**Rezoning from “Residential (Group C) 2” and “Open Space” zones to  
“Residential (Group C) 4” zone for a Proposed Residential Development  
at Lot Nos. 519 RP (part) and 520 RP in D.D. 110 and adjoining Government land,  
Shek Kong, Yuen Long, N.T.**

**Rezoning from “Residential (Group C) 2” to “Open Space” zone  
at Lot Nos. 121, 137, 138, 139 S.A and 139 RP (part) in D.D. 110  
and adjoining Government land, Shek Kong, Yuen Long, N.T.  
(S12A Amendment of Plan Application No. YYL-KTN/6)**

**- Further Information No. 3 -**

**Comments Forwarded from Fanling, Sheung Shui and Yuen Long East District Planning Office (FSS&YLE DPO)**

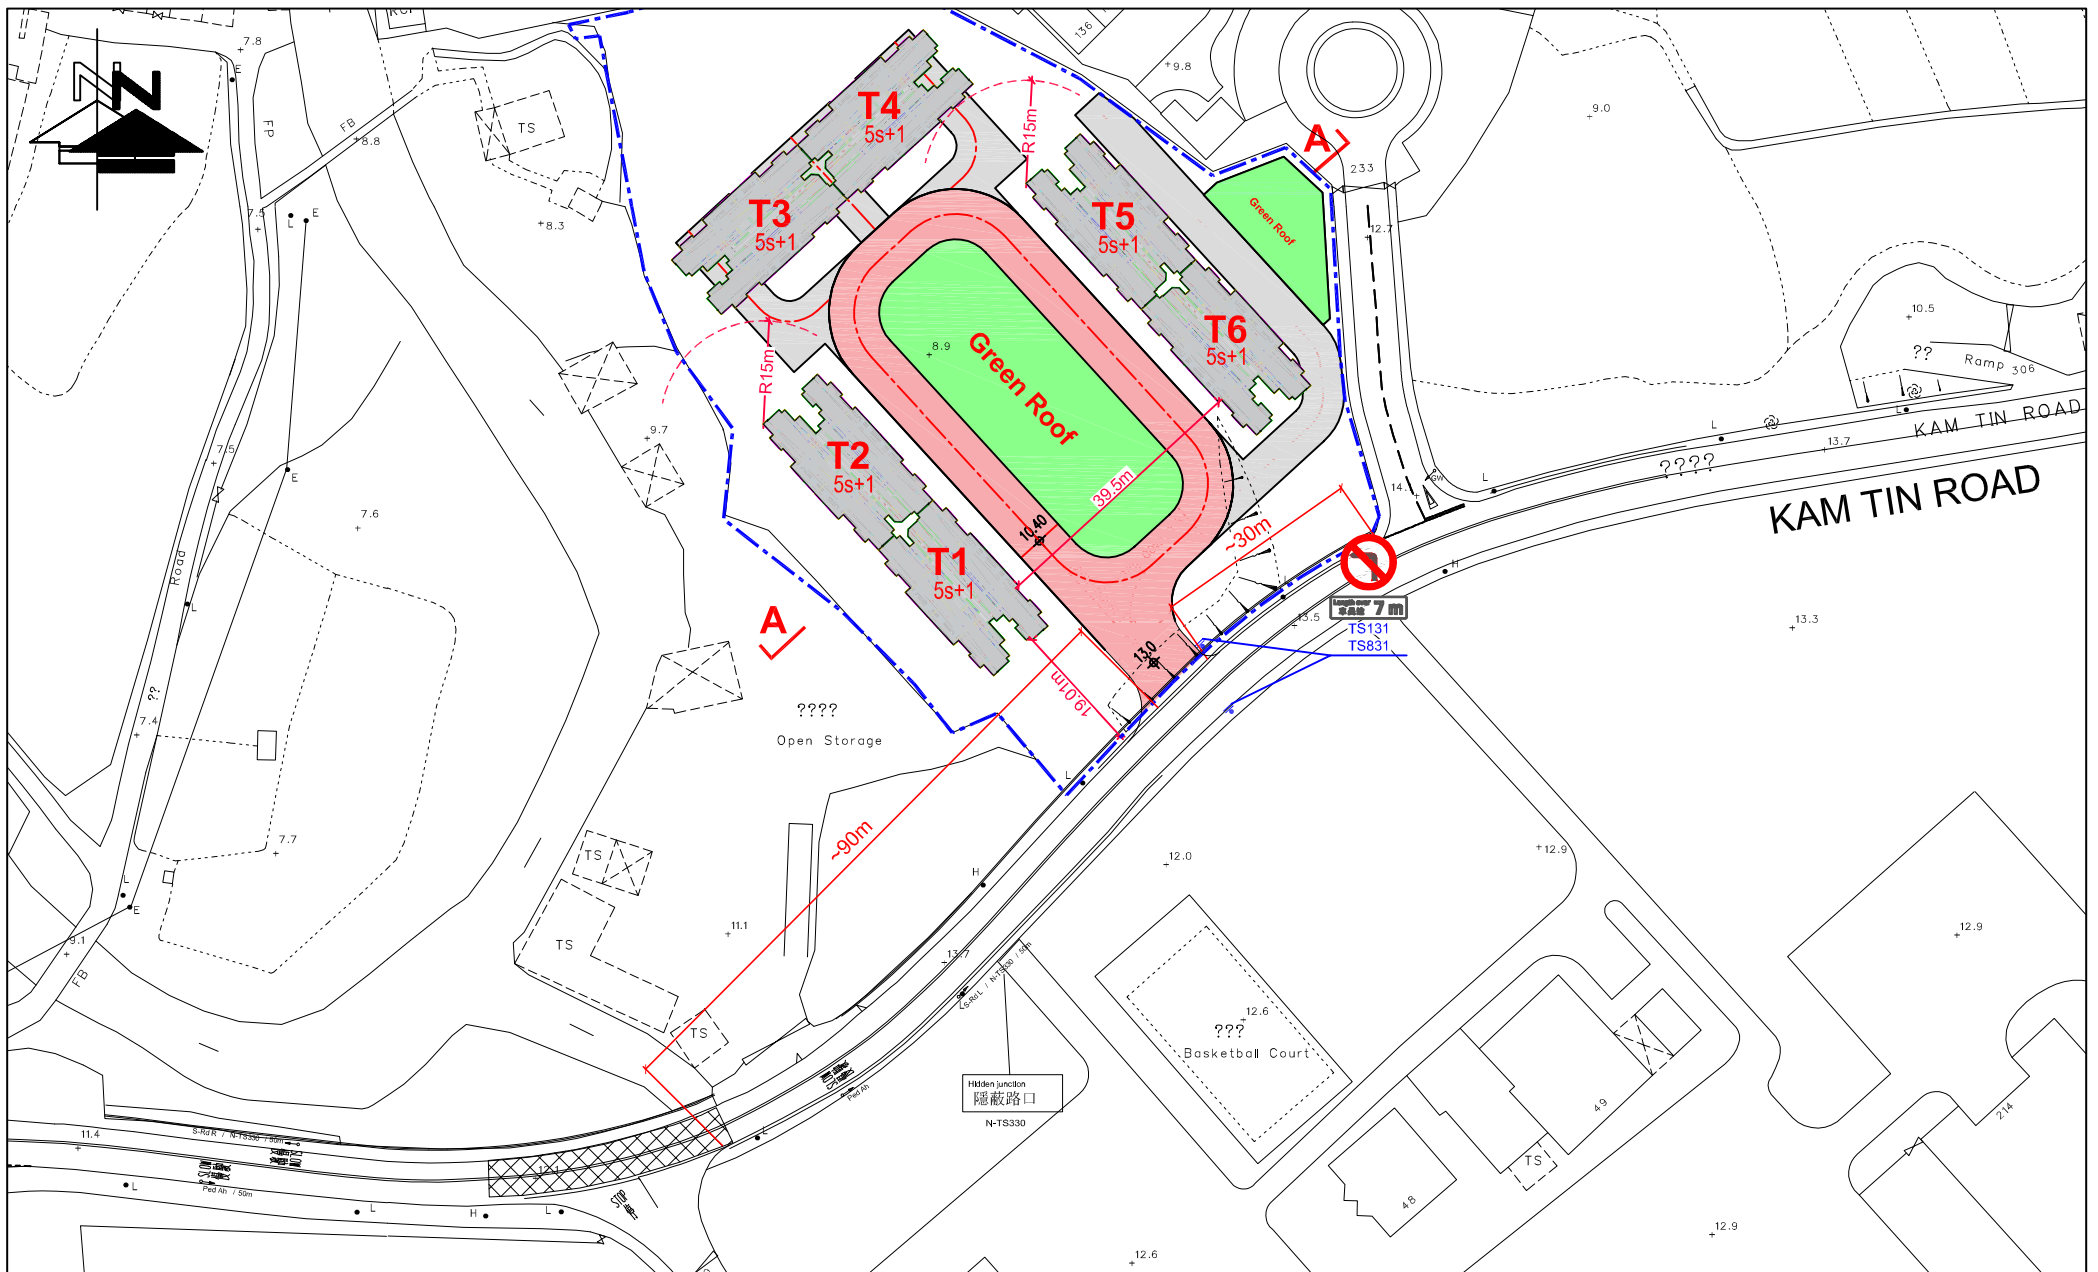
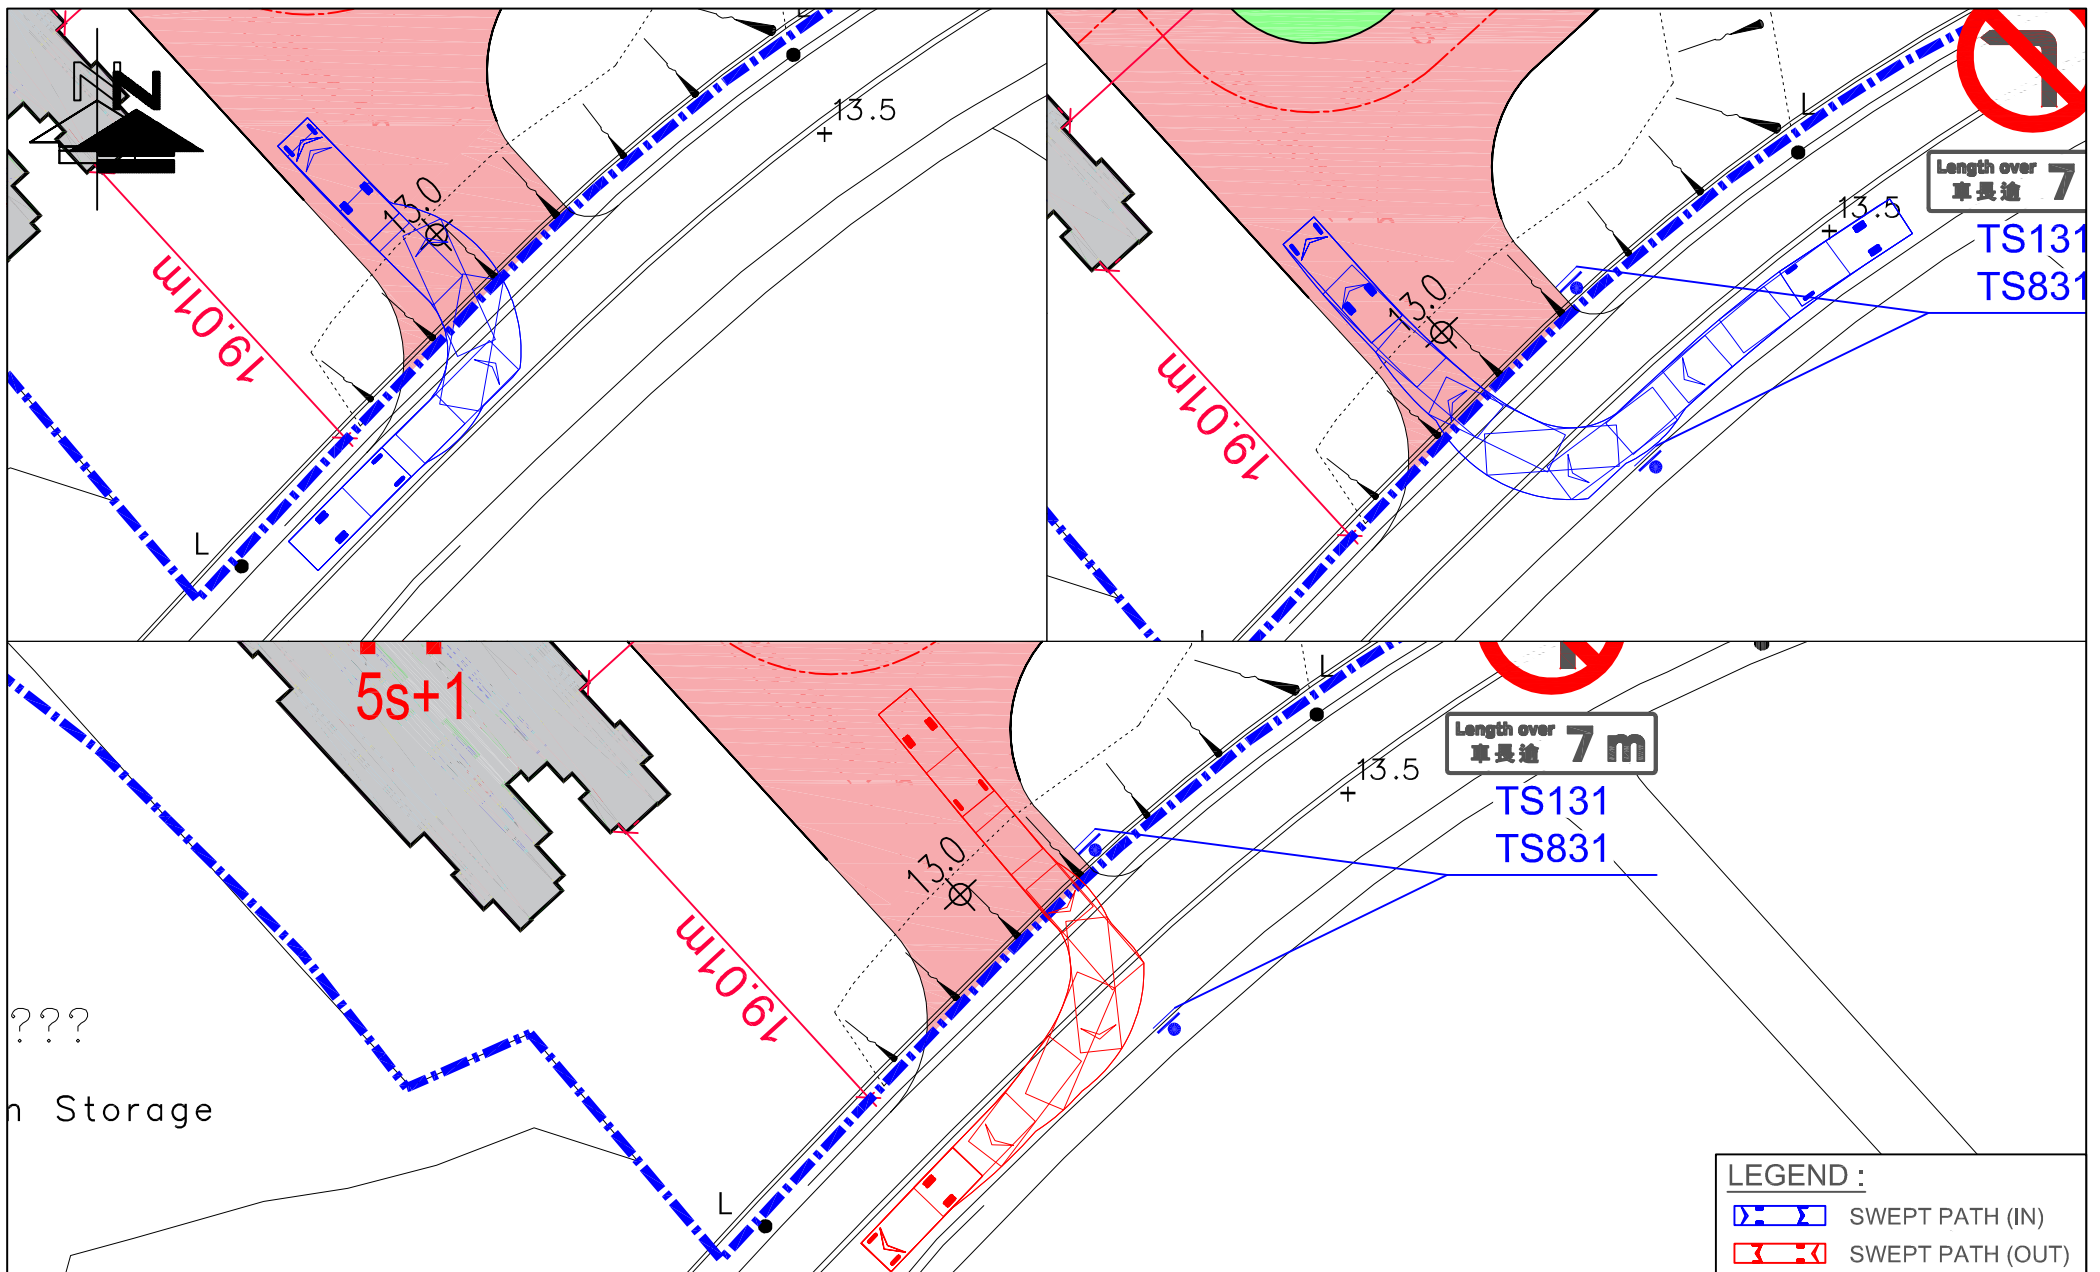
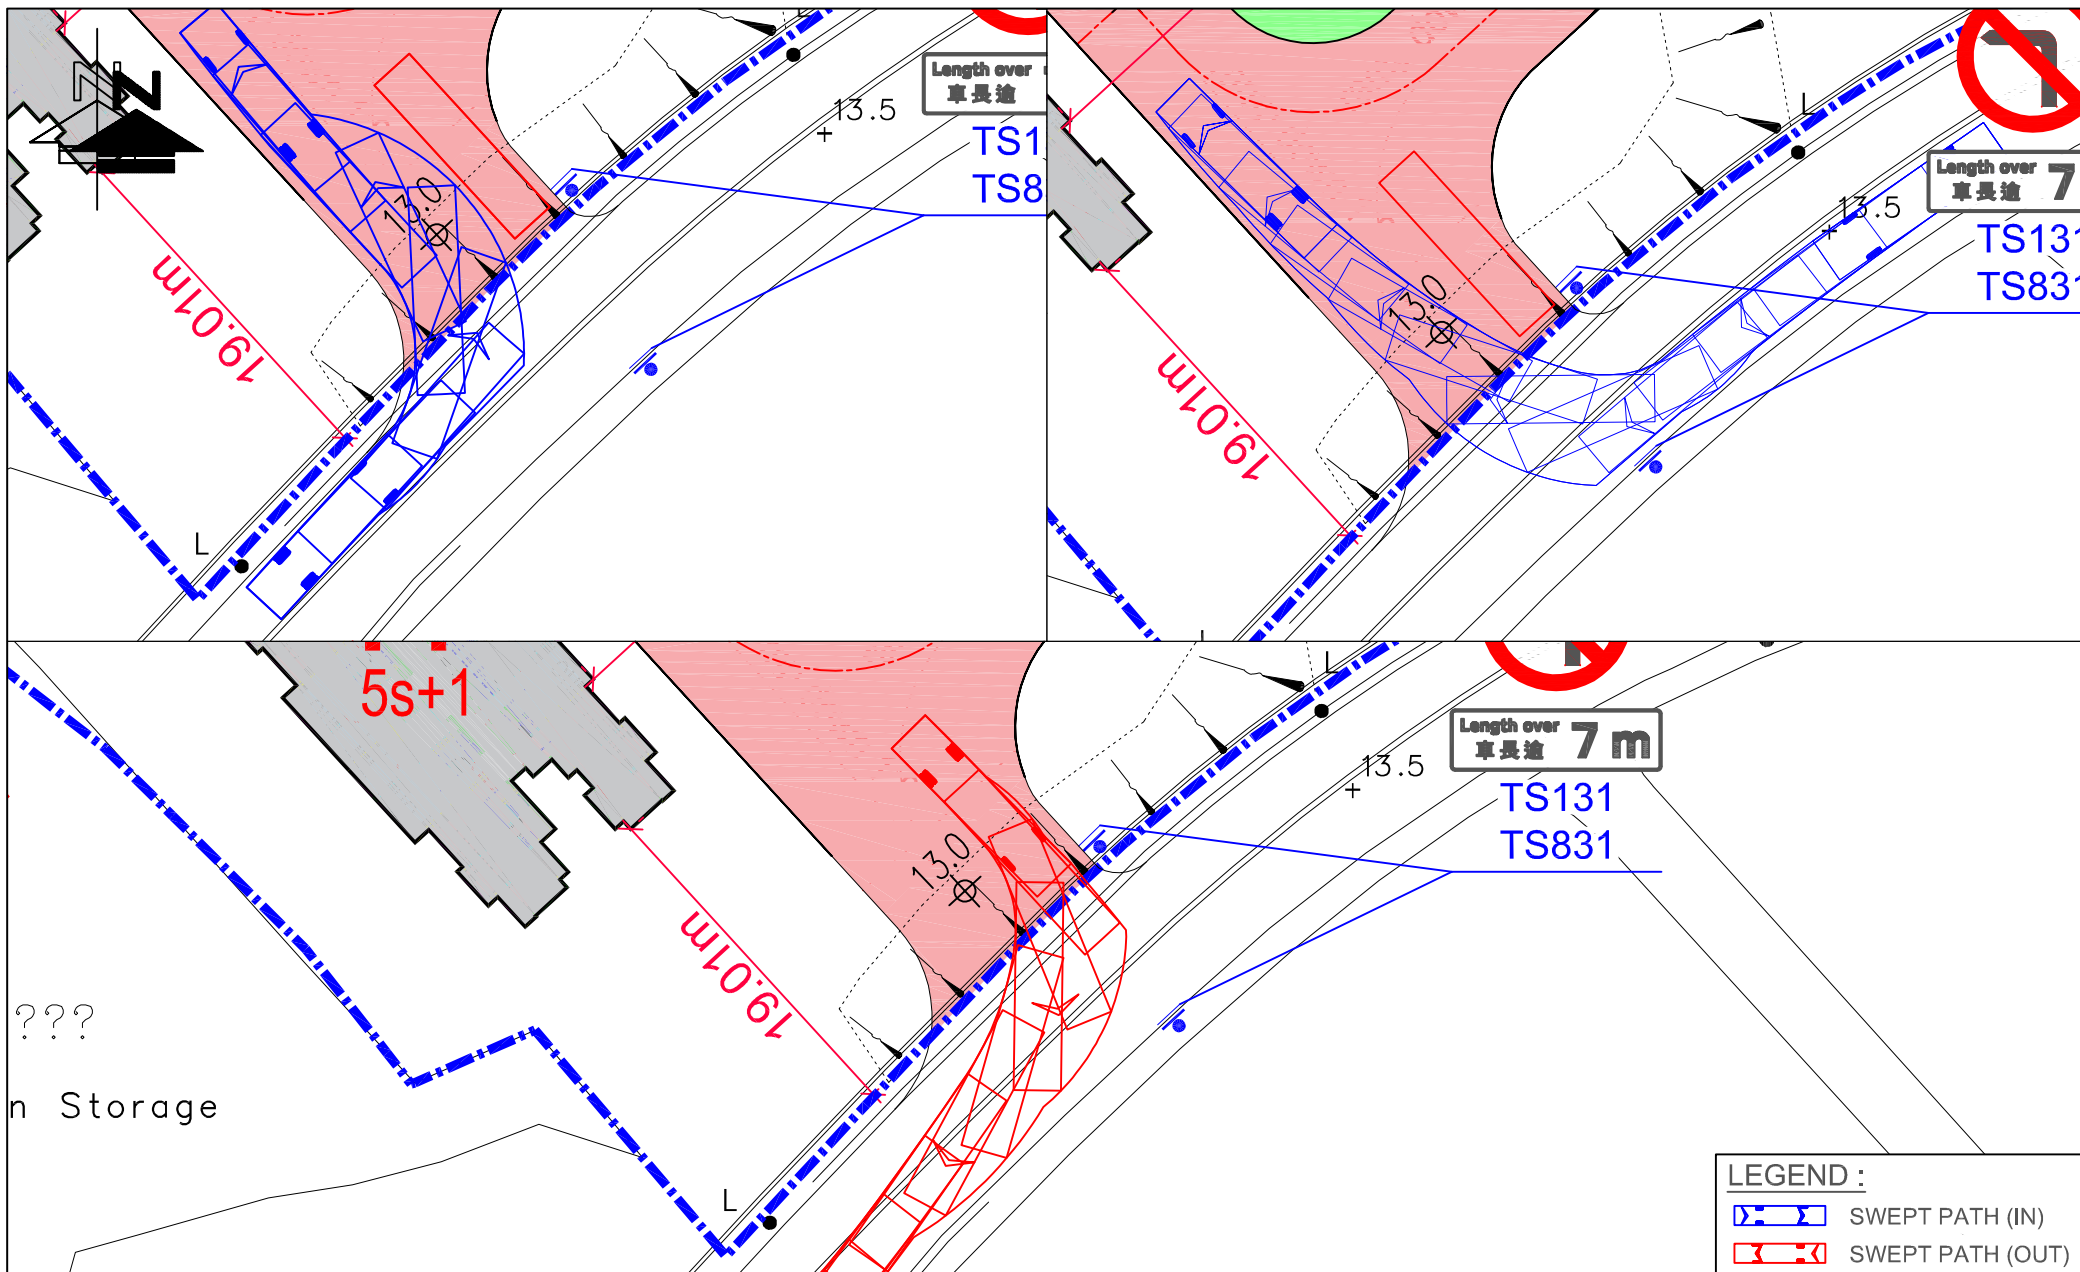
8. Figure 2.1 - the distance between the development run-in/out and the nearest junction shall be indicated. The applicant should also advise whether this could fulfill the requirement in TPDM.	The distance between the development run-in/out and the nearest junction (Kam Tin Road/ Avenue De Versailles) are shown in <b>Figure 2.1</b> of the TIA report. The distance is min. 30m, which fulfills the requirement in TPDM.

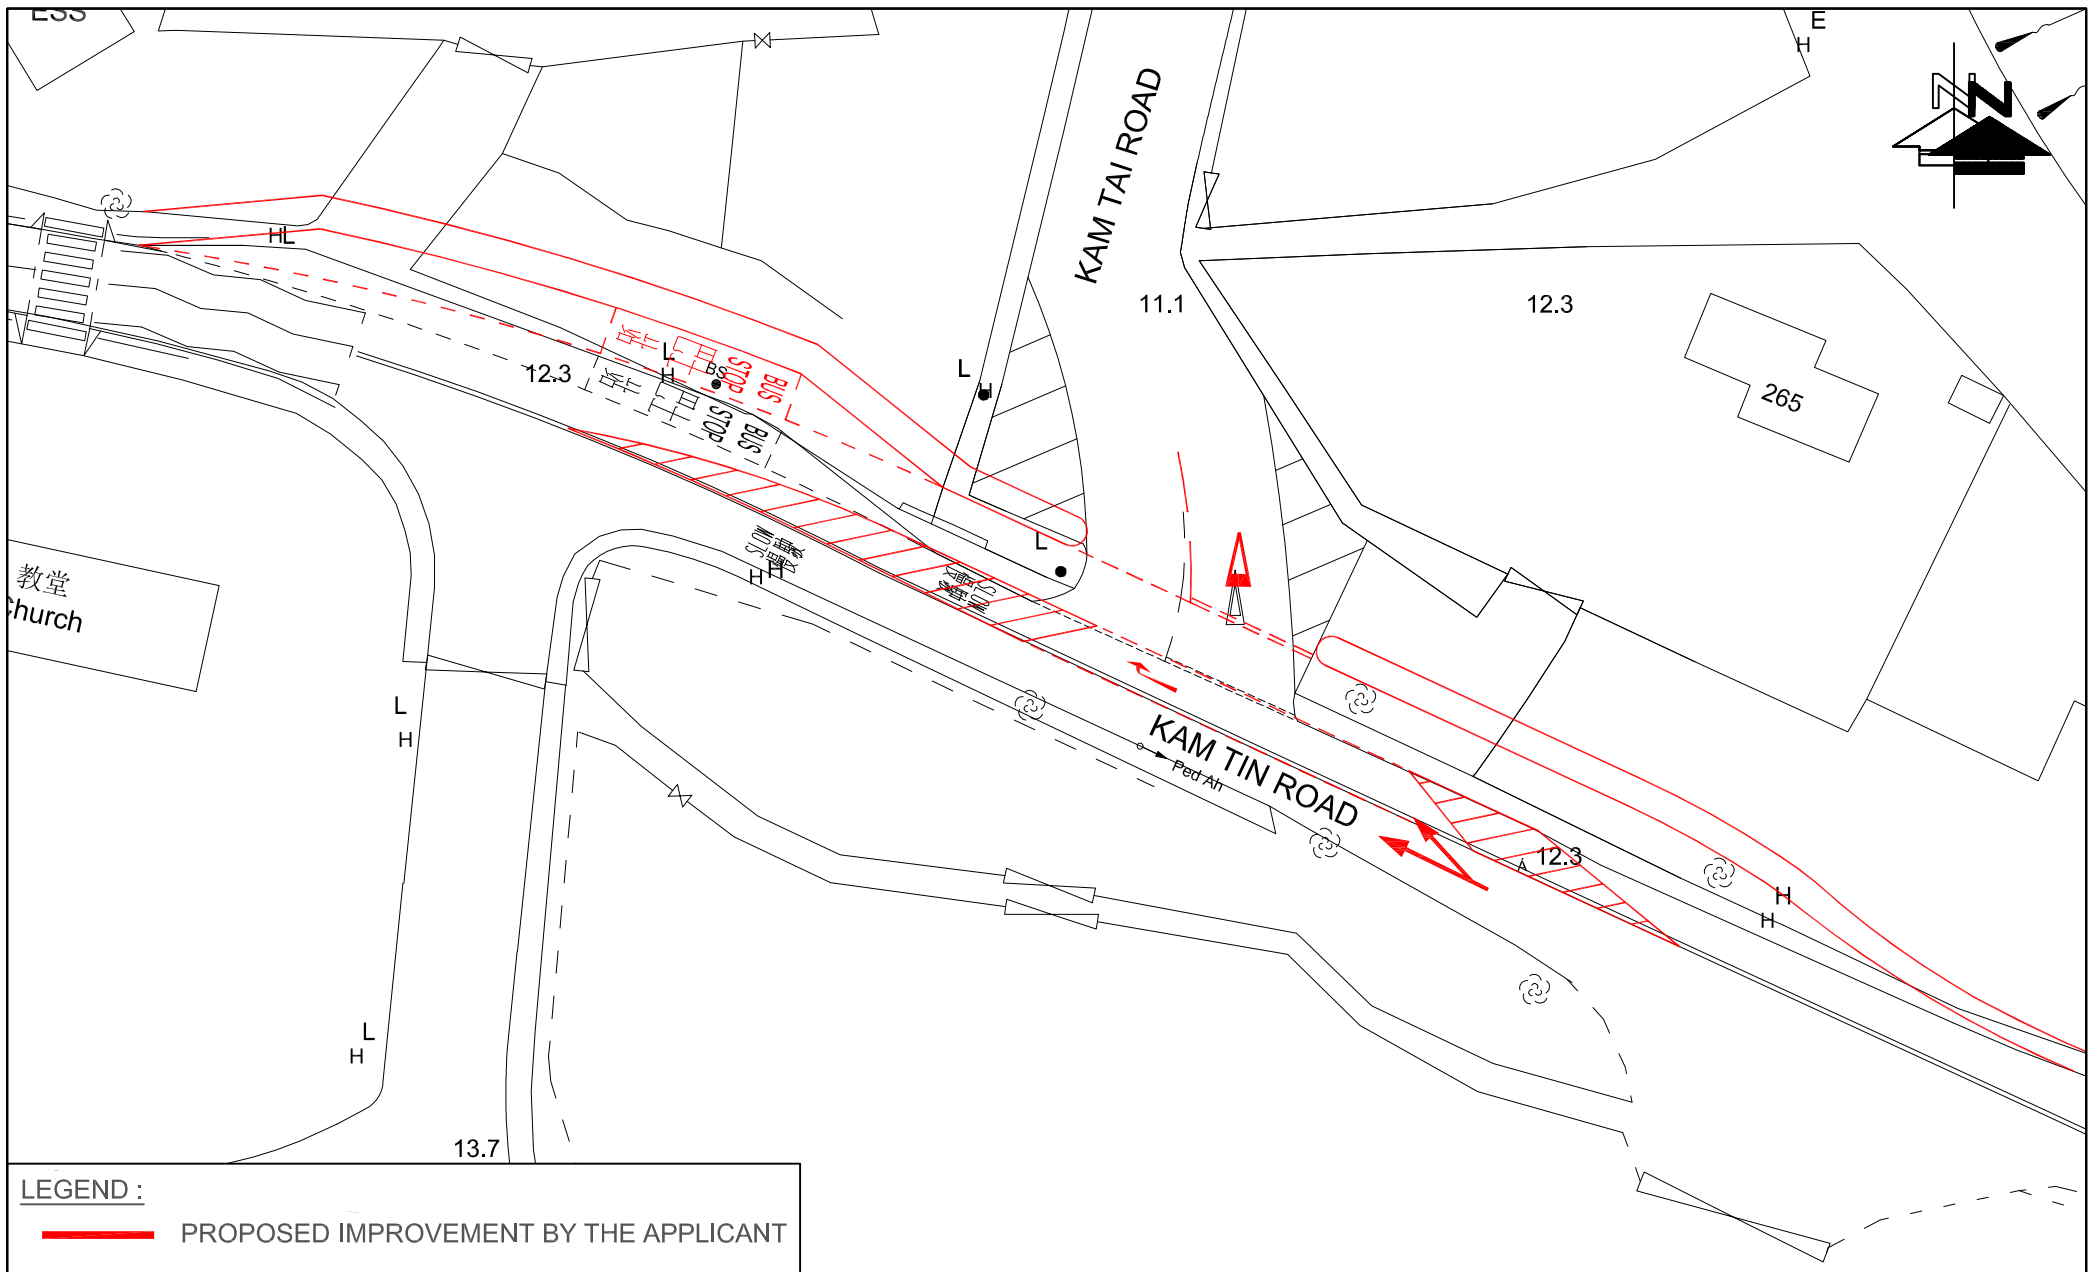
9. Figure 5.1 - in general the proposed improvement works ties in with the development, e.g. population intake, BC date etc, but not a public works. Please demonstrate when the improvement work would be carried out.	The improvement works will be carried out and completed before the population intake of the proposed development, in case of programme mis-match between the development and the public works project.
<b>Comments from Environmental Protection Department (received on 25 February 2026)</b> <b>Contact person: Mr. Kelvin WONG; Tel. No.: 2835 1117</b>	
It is understood from the RtC table that the consultant is waiting information from TD to address his previous comment (i.e. comment 2(ii) for the Air Quality Impact Assessment). As such, please update the report accordingly once information from TD has been received. Also, please delete the newly added sentence " <i>With reference to the lease of Seasons Villas (Lot 815 RP &amp; Ext Thereto in DD110), this road is a non-exclusive right-of-way maintained by the owners of Seasons Villas.</i> " from S.7.1 of the report. Other than the above, we have no further comment.	As per verbal conversation and written reply by TD, Avenue de Versailles is not under TD's management and thus TD consider not in position to comment on its road type.  Since Avenue de Versailles connects to Season Villas only, according to Volume 2 Chapter 3.2 of Transport Planning and Design Manual (TPDM) published by TD, it is regarded as a feeder road.  Based on the Annual Traffic Census 2024 (ATC) published by TD, Kam Tin Road (ATC Station no.6207) is Rural Road. TD has no comment on the road type of Kam Tin Road.

8.1.7 Concerning the scale of the whole PWP works of widening of Kam Tin Road is substantial, it cannot be carried out solely by the private sector. Thus, local widening (i.e. **Figure 5.1** Junction C) rather than full length of Kam Tin Road will be carried out by the Applicant to minimize the impact to traffic, in case of programme mismatch between the development and the public works project.
